**Written submission from
Northwatch**

Application for the renewal of the nuclear
research and test establishment
decommissioning licence for the Whiteshell
Laboratories site

**Comment on an Application from
Canadian Nuclear Laboratories Ltd. to renew its
Nuclear Research and Test Establishment Decommissioning
Licence for the Whiteshell Laboratories**

Ref. 2024-H7

Figure 1, UFTP SAR-MFT, SECTION 1.2.1.2

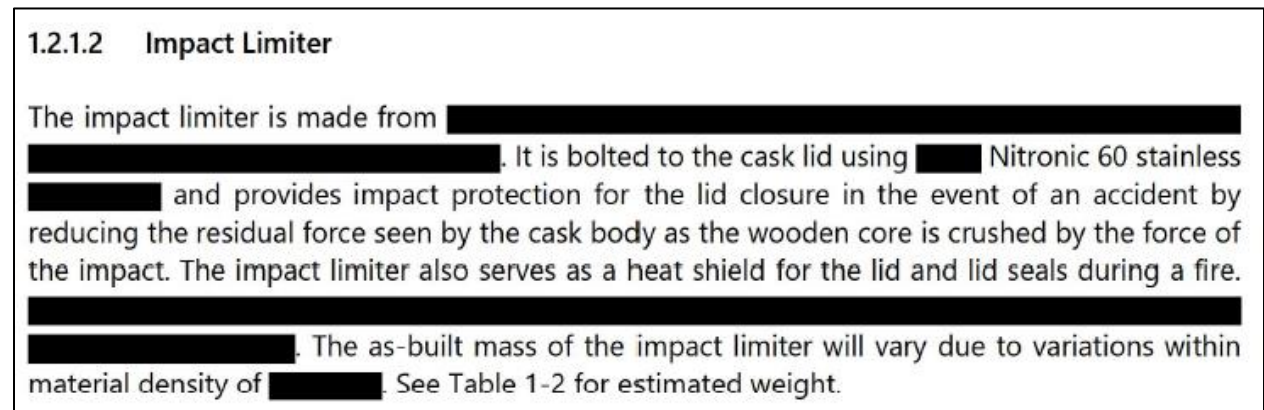
It is Northwatch’s assessment that a not-yet-determined number of the redactions were simply vexatious in nature. For example, in Section 1.2.1.2 the description of the impact limiter is redacted, including what we expect – although cannot confirm, due to the redaction – was a simple description of the materials in the impact limiter is constructed from. However, in a later section – Section 1.1.1.3 - the impact limiter is described as being made of redwood encased in stainless steel.²⁰ This description can be found elsewhere in the public domain and we can conceive of no reason – for security or proprietary purposes – why this very basic description would have been redacted.
